Item Name: Crosstube Turning Detail

DART AEROSPACE LTD	Work Order:	144337
Description: Crosstube Assembly (206B High Fwd)	Part Number:	D206-667-141
Inspection Dwg: D206-667-141 Rev: C		Page 1 of 2

DRAWING NO. D206-667-141	TITLE CROSSTUBE ASS'Y (206B HIGH FWD)	REV. C	DART AEROSPACE LTD ENGINEERING ORDER		D.E.O. NO. D206-667-141-C-1	SHEET NO. SHEET 1 OF 1	SCALE NTS
DRAWN <i>Q</i>	CHECKED <i>ASS</i>	MFG. APPR. <i>MD</i>	APPROVED <i>MD</i>		DE APPR. <i>MD</i>		
DATE 11.07.15	DATE 11.07.20	DATE 11.07.21	DATE 11/07/21		DATE 11.07.21

DRAWING NO. D206-667-141		TITLE CROSSTUBE ASS'Y (206B HIGH FWD)		REV. C DART AEROSPACE LTD ENGINEERING ORDER		D.E.O. NO. D206-667-141-C-2		SHEET NO. SHEET 1 OF 1		SCALE NTS	
DRAWN AJS		CHECKED J		MFG. APPR. E		APPROVED AP		DE APPR. H			
DATE 12.08.02		DATE 12.08.02		DATE 12.08.02		DATE 12.08.02		DATE 12.08.02

DETAIL P
BONDING STRAP INSTALLATION 2 PL

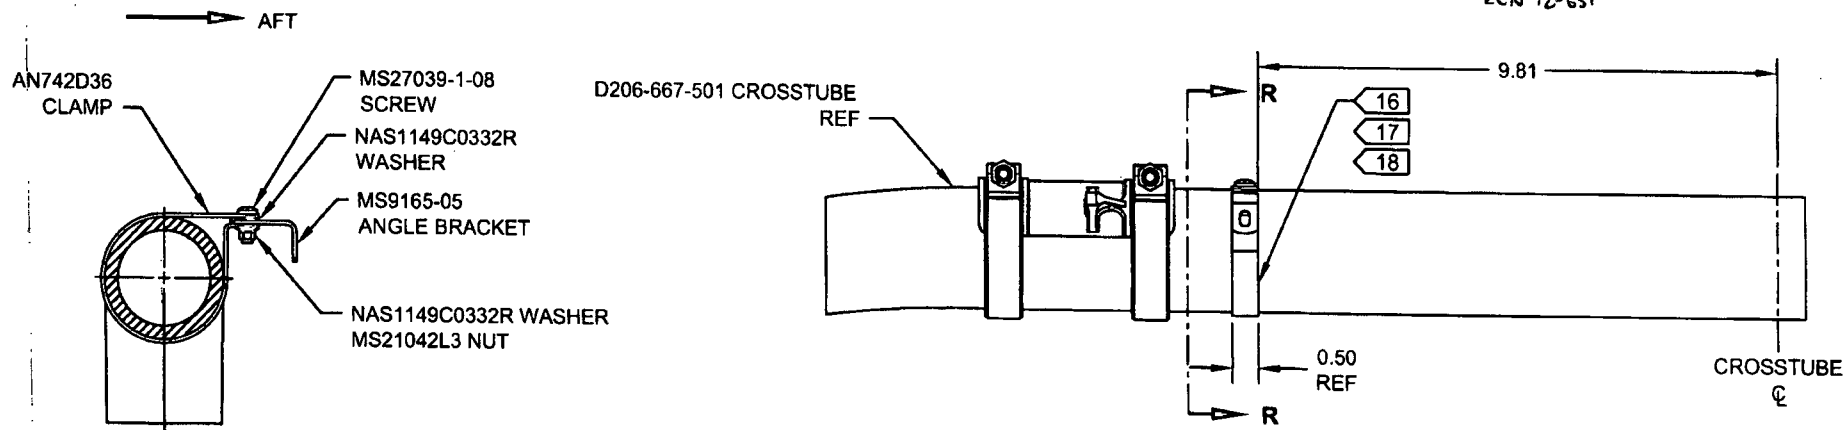
ADD ELECTRICAL GROUNDING STRAP

- 16) MASK AREA UNDER CLAMP PRIOR TO PAINTING
- 17) SEAL EDGES WHERE AN742D36 CLAMP MEETS WITH THE CROSSTUBE USING SIKAFLEX-241/-291 OR MIL-S-8802 CLASS B2 OR PROSEAL 890 SEALANT
- 18) PERFORM RESISTANCE CHECK TO ENSURE MAX RESISTANCE IS 10 MILLIOHMS

ITEM	QTY -141	PART NUMBER	DESCRIPTION
1	X	D206-667-141	CROSSTUBE ASSEMBLY (206B HIGH FWD)
10	2	AN742D36	CLAMP
11	2	MS9165-05	ANGLE BRACKET
12	2	MS21042L3	NUT (OR MS21042-3)
13	2	MS27039-1-08	SCREW
14	4	NAS1149C0332R	WASHER (OR AN960C10L)
